Illinois Tollway Base Sheet Revisions
--

Section M	Base Sheet Drawings	
Drawing	Modification Summary	Effective: 2019-03-01
Pole Assembly (ITS)-Series 1000		
M-ITS-1000	Elevation Views Pole Mounted ITS Element Assembly Changed disconnect switch to unfused.	
M-ITS-1003	ITS Concrete Service Pad (2 sheets) New drawing with three types of service pads for ITS poles for flat and slope installation.	
M-ITS-1004	Cabinet Wiring Diagram - ITS Pole Mounted Enclosure (Solar Powered MVDS) (2 sheets) New cabinet layout separating ITS enclosure and dedicated co-located solar generator/battery cabinet with four 6 V batteries.	
Dynamic Message Sign (ITS)-Series 1100		
M-ITS-1108	DMS Cabinet Wiring Diagram Changed to Cisco 4000 series switch. Changed IP Relay to DIN IV.	
Cabinet Wiring (ITS)-Series 1200		
M-ITS-1200 to M-ITS-1217	Cabinet Wiring Diagrams 18 new ITS enclosure drawings replace old 56 ITS enclosure drawings for clarification. Drawings 1200 to 1217 have been redone completely. Consolidated equipment configurations. Standardized to-scale equipment layout. Changed to Cisco 4000 series switch. Eliminated 24 VAC transformer and 24 VAC CCTVs. Additional 24 VDC power supply. Cat6 Ethernet sur

SHEET 4 OF 4
BASE SHEET M-ITS-2000

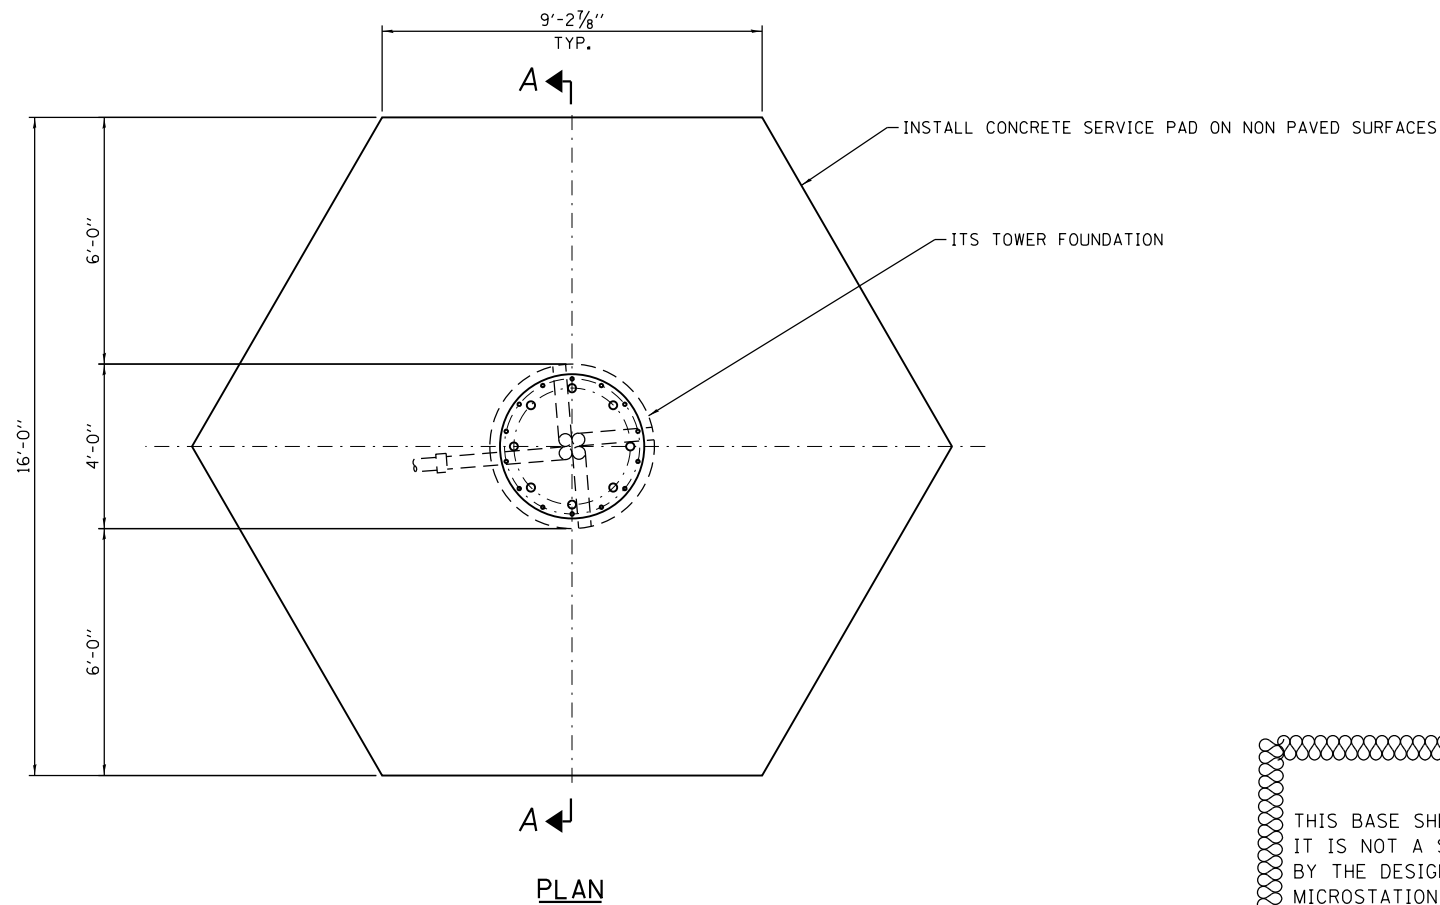
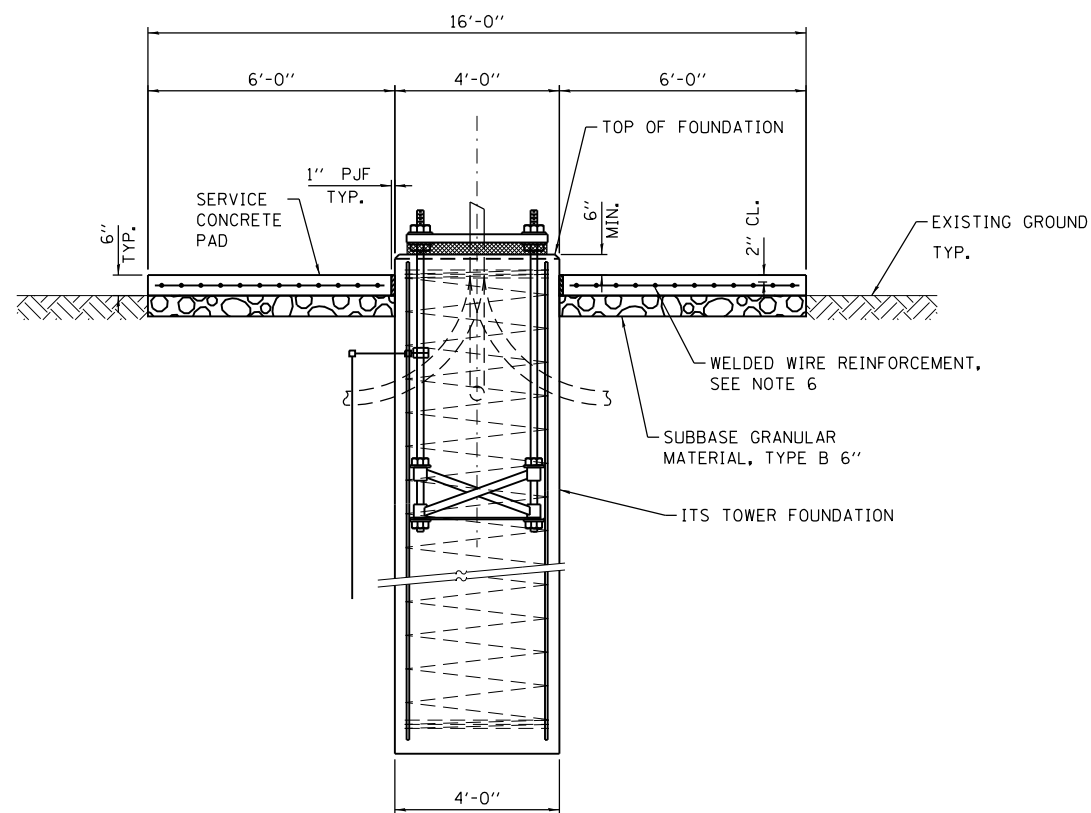
100 FT. Monopole (ITS)-Series 2000		
M-ITS-2000 Sheet 4	100 FT. Monopole Closed Circuit Television (CCTV) Camera Tower Added sheet 4 of 4 showing hexagonal service pad.
